PCN / EOL Notification

Product Change Notification Number: NC101804

Title: Automotive ATtiny87 ATtiny167 with LIN2.1 Slave Mode Break Field Detection Correction

Figure 2.5: The break field

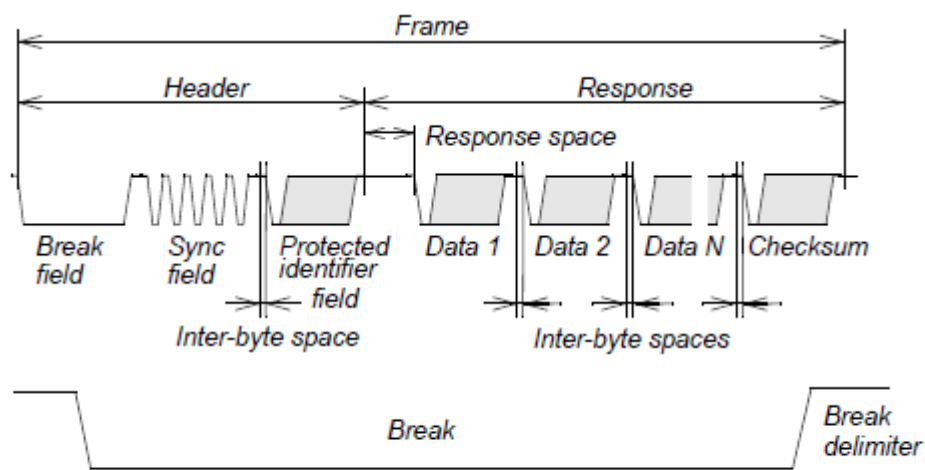
Certification failure in the SLAVE MODE BREAK field detection.

The problem occurs if 2 conditions occur simultaneously:

1. The DOMINANT part of the BREAK is $(N+0.5)*T_{bit}$ long with $N=13, 14, 15, \dots$
2. The RECESSIVE part of the BREAK (BREAK DELIMITER) is equal to $1*T_{bit}$. (see note below)

The BREAK_high is not detected, and the 2nd bit of the SYNC field is interpreted as the BREAK DELIMITER.

The error is detected as a framing error on the first bits of the PID or on subsequent Data or a Checksum error.

There is no error if BREAK_high is greater than $1*T_{bit} + 18\%$.

Note: LIN2.1 Protocol Specification paragraph 2.3.1.1 Break field says: "A break field is always generated by the master task(in the master node) and it shall be at least 13 nominal bit times of dominant value, followed by a break delimiter, as shown in Figure 2.5. The break delimiter shall be at least one nominal bit time long"

LIN master implementations usually generate a break delimiter of $2*T_{bit}$ or more. LIN Slave applications connected to such a Master will not exhibit the problem.
